Base Load Power Hub (BLPH)

HAZOP Close Out Report

Document Number: 123A90-DDL-SAF-RE-30007

CONTRACT NO./TITLE	CW-I-WP4-2023-05/HOLLANDSE KUST NOORD WIND PARK		SCALE	NTS
DRAWN	CHECKED	APPROVED	DATE	
A1	DRAWING NO. 123A90-DDL-PR-PID-80014		SHEET 001	REV. 01

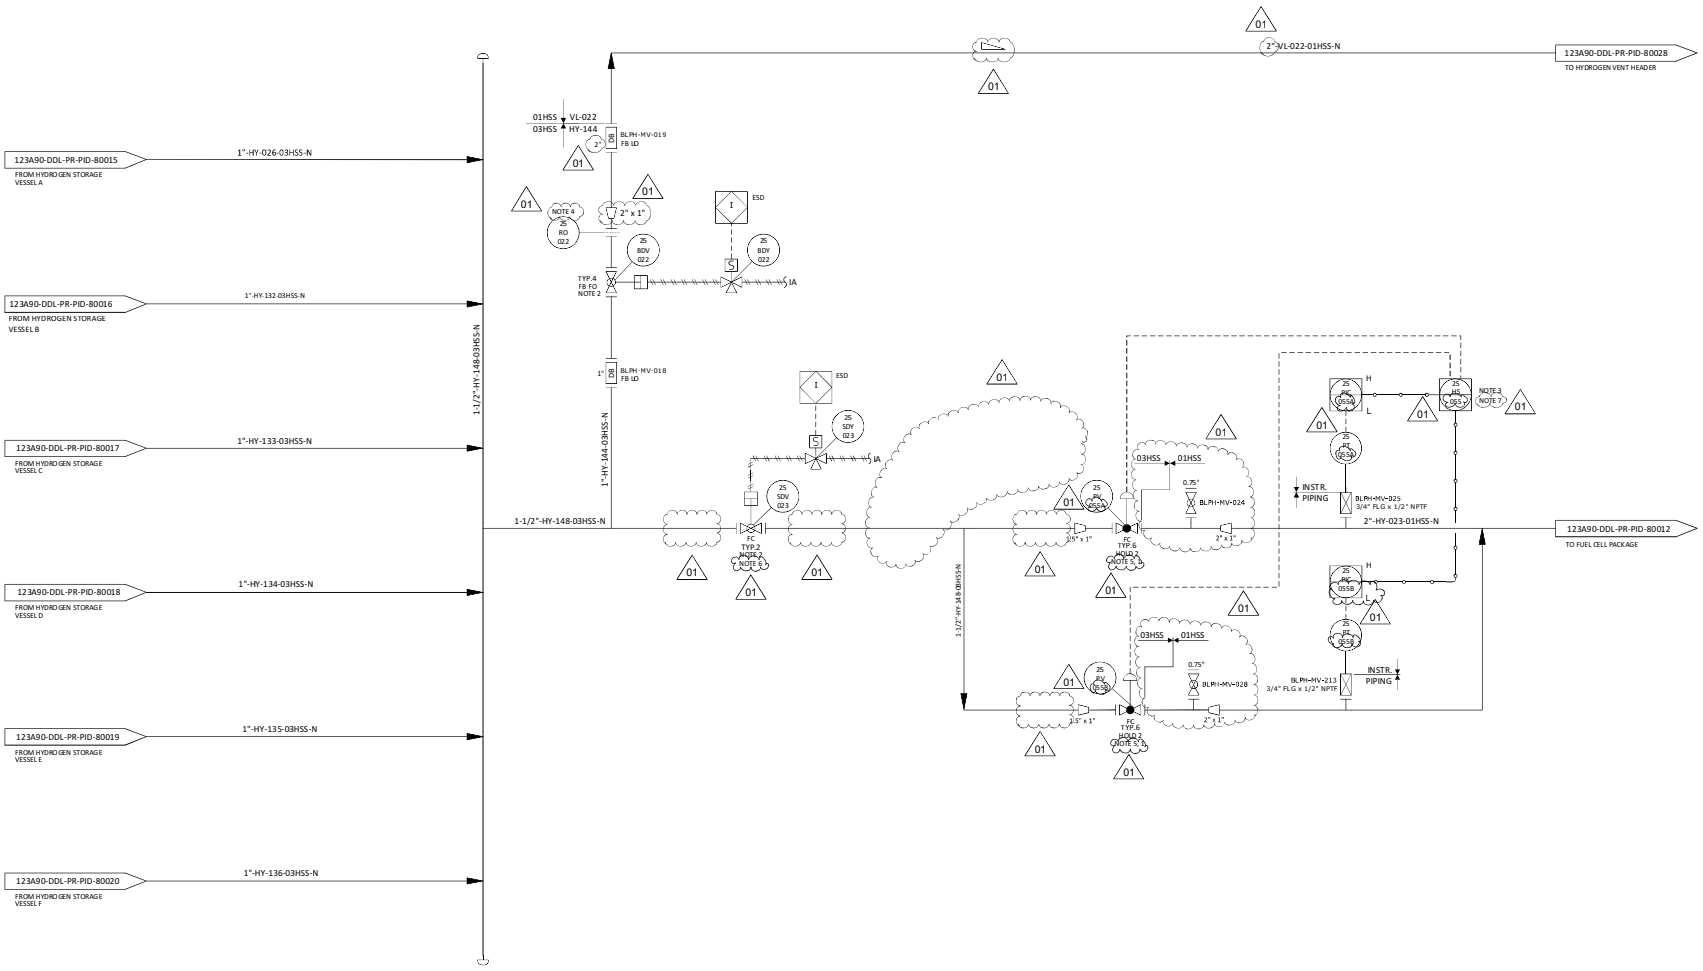
Action Title: **Ref. Doc.**	**HAZOP Study Actions** K559-2254-SE-REP-015
Item No.	6
Cause:	Open Blowdown Valve
Consequence:	Continuous venting of hydrogen. Leading to environmental emissions.
Safeguards:	
Actions:	Review necessity of emergency blowdown for hydrogen feed & distribution manifold.
Assigned Respondent (By)	ROSETTI Process Engineer
RESPONSE	Emergency blowdown system has been reviewed during EPC phase. For reference see P&iDs: 123A90-DDL-PR-PID-80012_01, 123A90-DDL-PR-PID-80013_01 and 123A90-DDL-PR-PID-80014_01, attached to this Action as Attachment 1.
Attachments:	
Issue Date

A1	DRAWING NO. 123A90-DDL-PR-DG-80000	SHEET 001	REV. 01

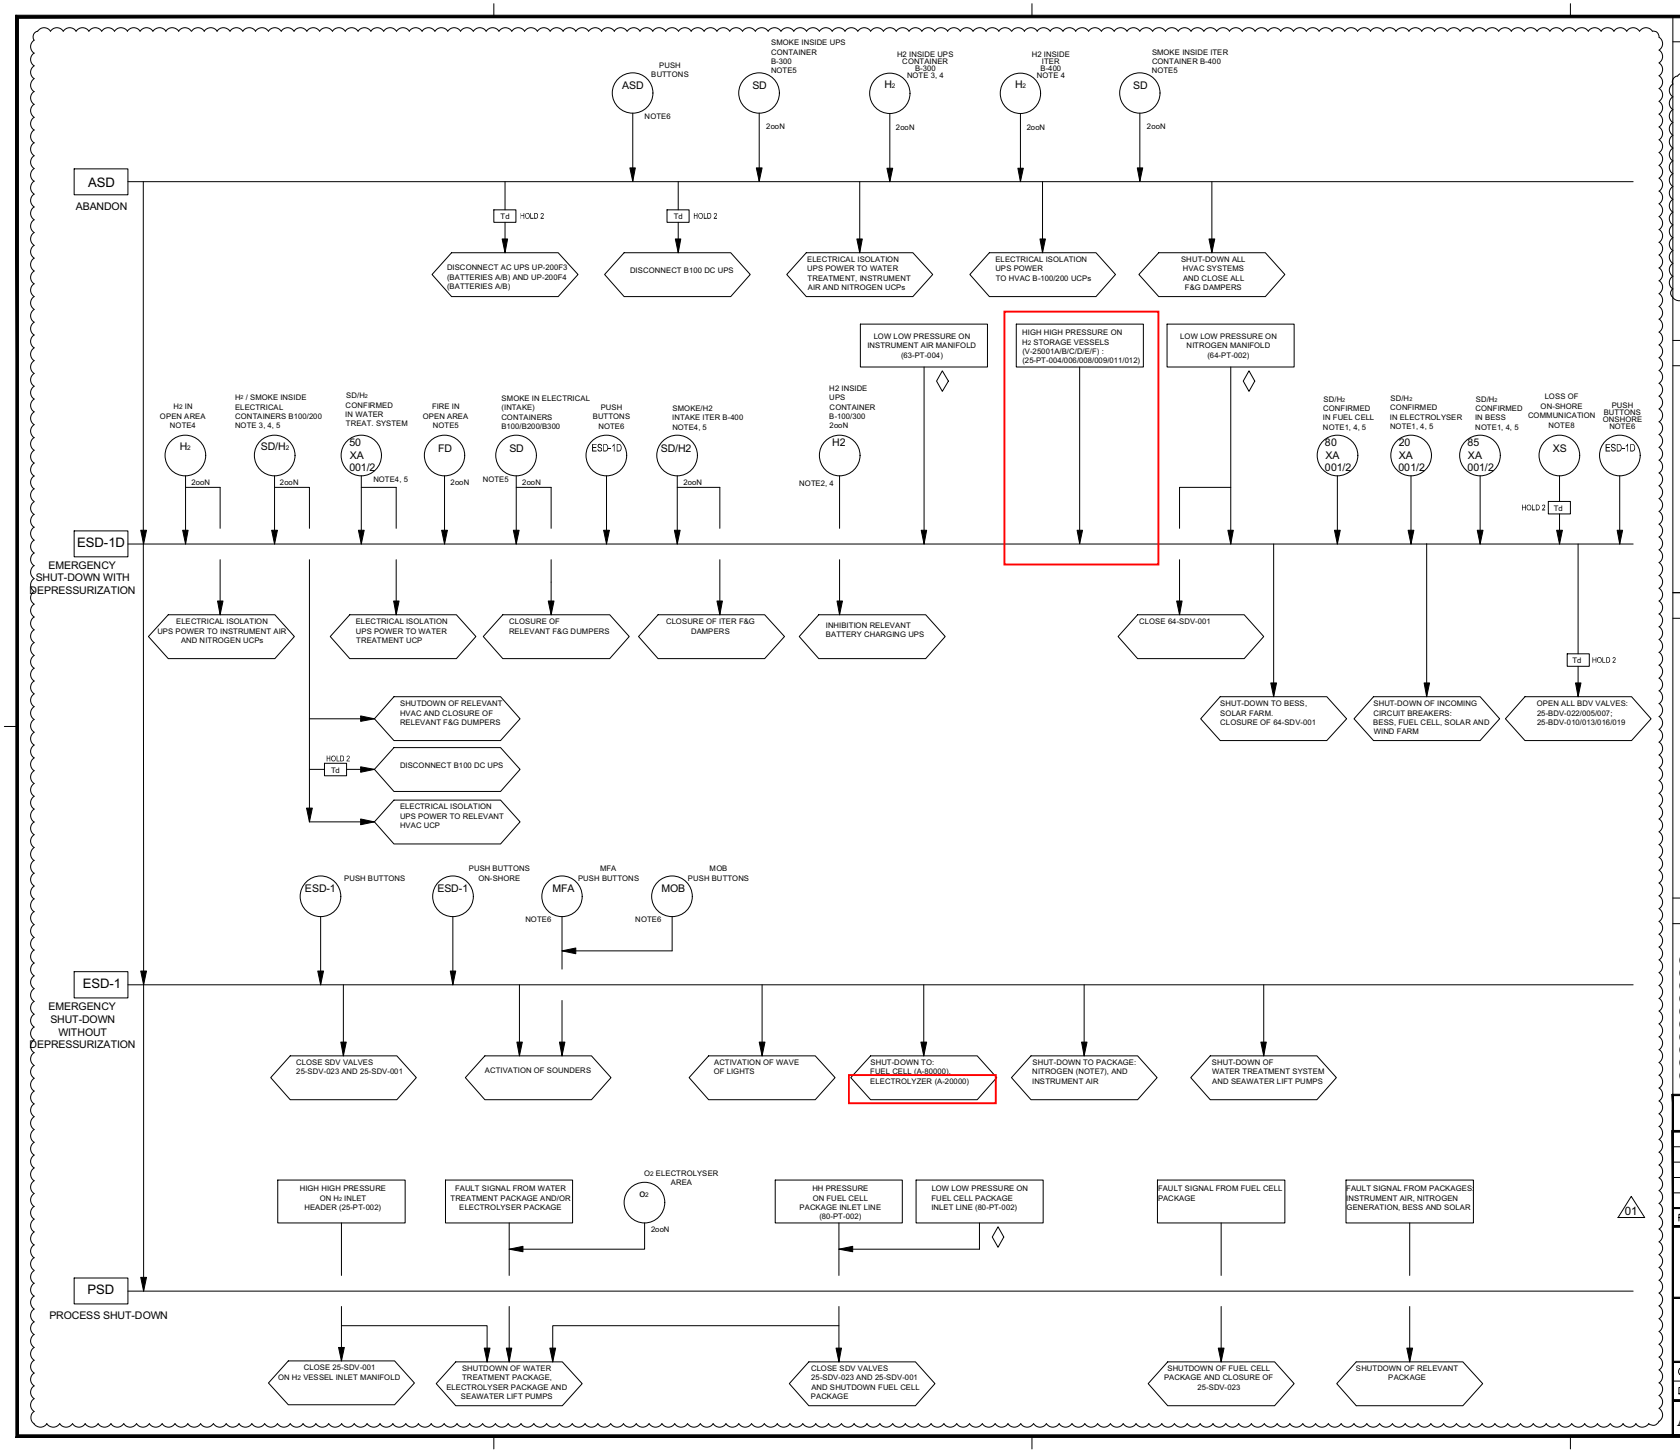
Action Title: **Ref. Doc.**	**HAZOP Study Actions** K559-2254-SE-REP-015
Item No.	14
Cause:	Electrolyser continue operation.
Consequence:	Overpressure of hydrogen storage. See 2.9- Pressure More.
Safeguards:	
Actions:	Review control system design to ensure that potential overpressure can be reliability detected, and PEM electrolyser package shutdown initiated.
Assigned Respondent (By)	Rosetti Instrumentation Engineer
RESPONSE	As per project doc. "Process Safety Cause & Effect Block Diagram" n° 123A90-DDL-PR-DG-80000 rev.01, in case of overpressure of Hydrogen Storage Tanks the Pressure Transmitters 25-PT-004/006/008/009/011/012 (High High Alarm) will activate the ESD-1D with shutdown of Electrolyser package.
Attachments:	
Issue Date	24-04-2024

attachment 1 of action 16

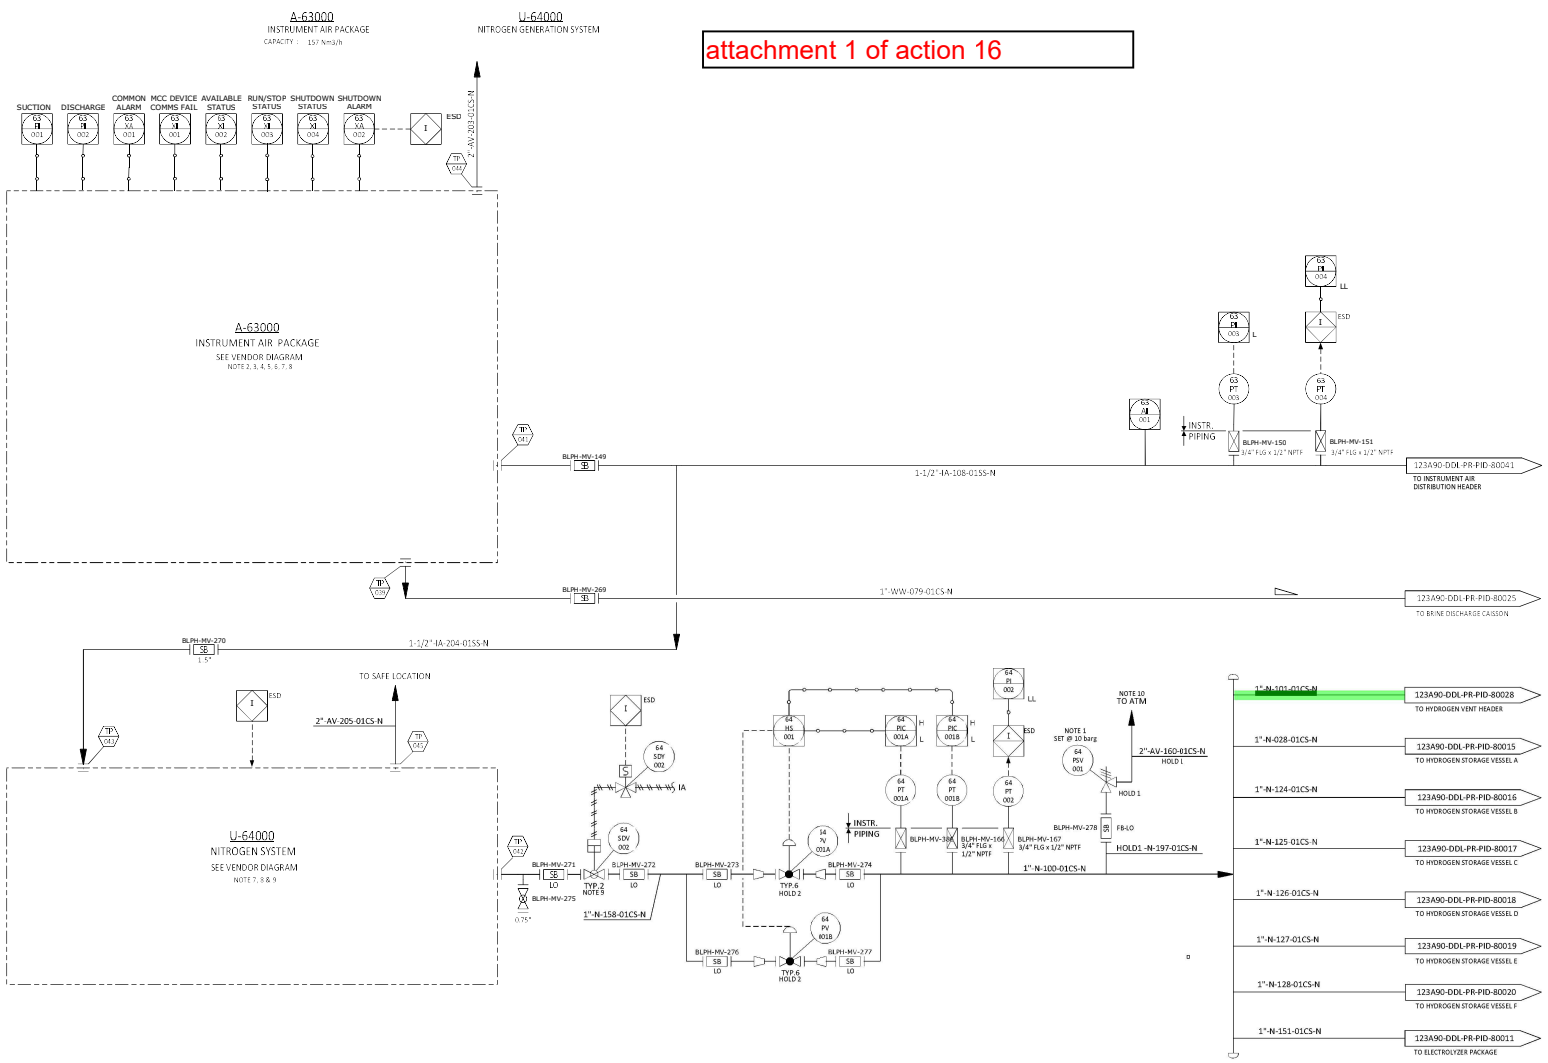
Action Title: **Ref. Doc.**	**HAZOP Study Actions** K559-2254-SE-REP-015
Item No.	16
Cause:	Loss of nitrogen at any cause
Consequence:	Potential air ingress into hydrogen vent. Leading to explosion, LOC & risk to personnel.
Safeguards:	
Actions:	Ensure secure nitrogen supply suitable for continuous purge of the hydrogen vent head is provided.
Assigned Respondent (By)	ROSETTI Process Engineer
RESPONSE	Nitrogen supply suitable for continuous purge of the hydrogen vent head is provided. For details see attachment 1.
Attachments:	
Issue Date (19-01-24)

attachment 1 of action 17

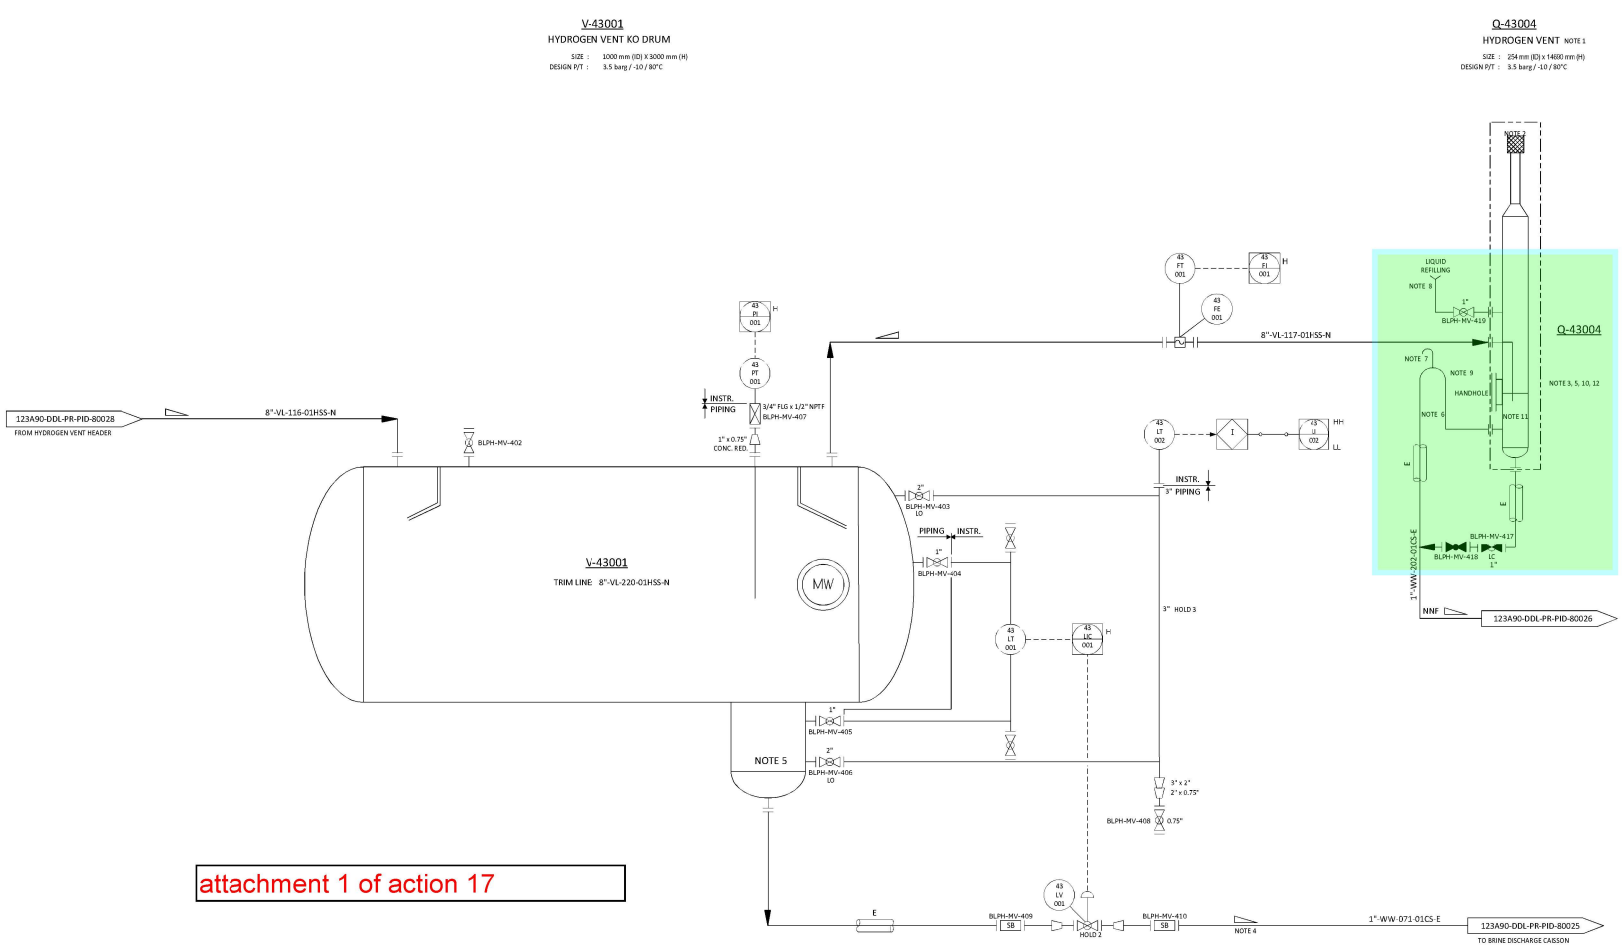
Action Title: **Ref. Doc.**	**HAZOP Study Actions** K559-2254-SE-REP-015
Item No.	17
Cause:	Loss of nitrogen at any cause
Consequence:	Potential air ingress into hydrogen vent. Leading to explosion, LOC & risk to personnel.
Safeguards:	
Actions:	In case of failure of primary nitrogen purge, ensure a suitable contingency plan is developed.
Assigned Respondent (By)	ROSETTI Process Engineer
RESPONSE	A liquid seal drum has been added. The aim of such seal is to avoid air ingress into hydrogen vent in case of loss of nitrogen purging. For reference see PID 123A90-DDL-PR-PID-80029, attachment 1
Attachments:	
Issue Date (19/01/24)

CONTRACT NO./TITLE	CW-I-WP4-2023-05/HOLLANDSE KUST NOORD WIND PARK		SCALE NTS
DRAWN	CHECKED	APPROVED	DATE
A1	DRAWING NO. 123A90-DDL-PR-PID-80029	SHEET 001	REV. 03

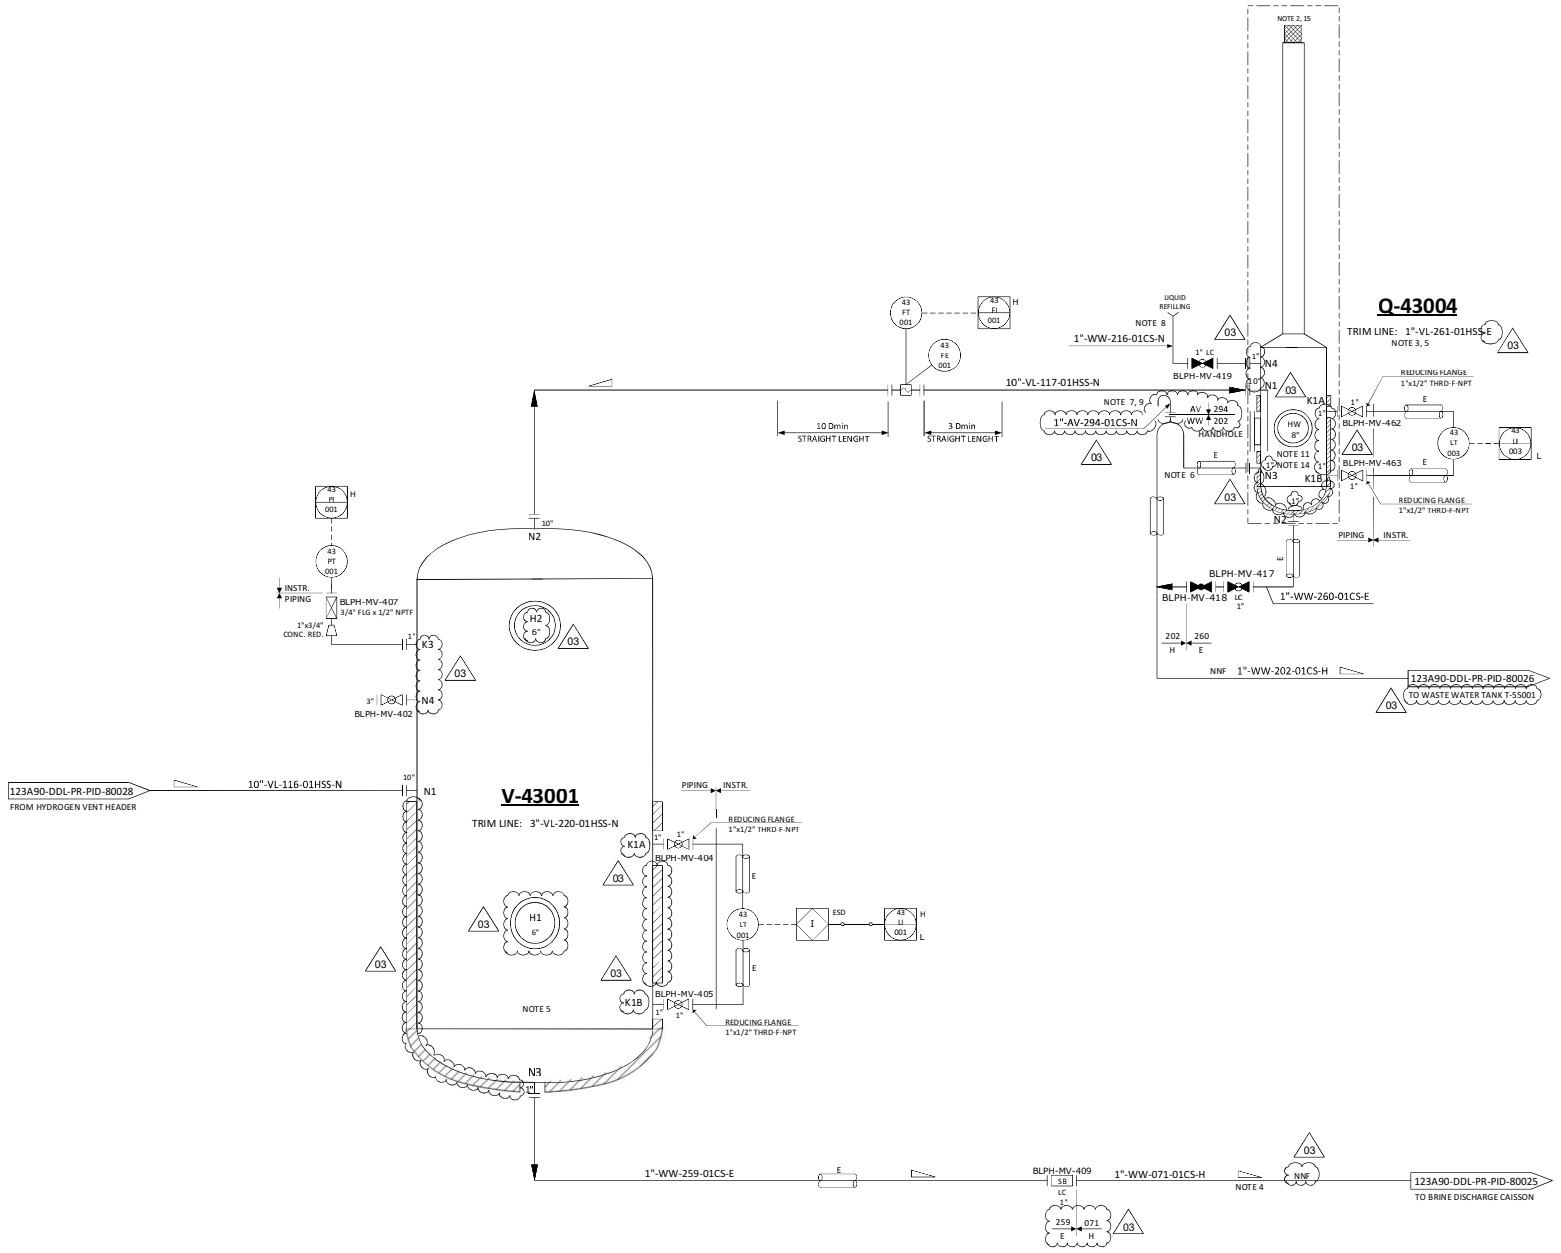
Action Title: **Ref. Doc.**	**HAZOP Study Actions** K559-2254-SE-REP-015
Item No.	18
Cause:	Water Vapour/Water
Consequence:	Potential freezing of vent lines, leading to back pressure & potential overpressure. Loss of safeguards i.e. blowdown & relief.
Safeguards:	
Actions:	Assess possibility of ice formation in hydrogen vent lines, from individual users into header, and provide suitable mitigation,
Assigned Respondent (By)	ROSETTI Process Engineer

RESPONSE	The only possibility to have water within the vent system is from the Electrolyser Package H2 vent. As per Elogen's reply to the TQ 123A90-PML-PM-TQ-00013 (attached), only water in the gas phase (H2 off-spec) is expected. Should part of this water condensate, all lines downstream relief and blowdown devices are sloped toward to the H2 Vent KOD, where water will be collected. Moreover, the H2 Vent KOD boot will be heated together with the liquid discharge line. Therefore, the ice formation on the sloped vent lines is not a credible scenario. For reference see P&iDs 123A90-DDL-PR-PID-80011, 123A90-DDL-PR-PID-80028 and 123A90-DDL-PR-PID-80029 (attached).
Attachments:	
Issue Date (dd/mm/yy)
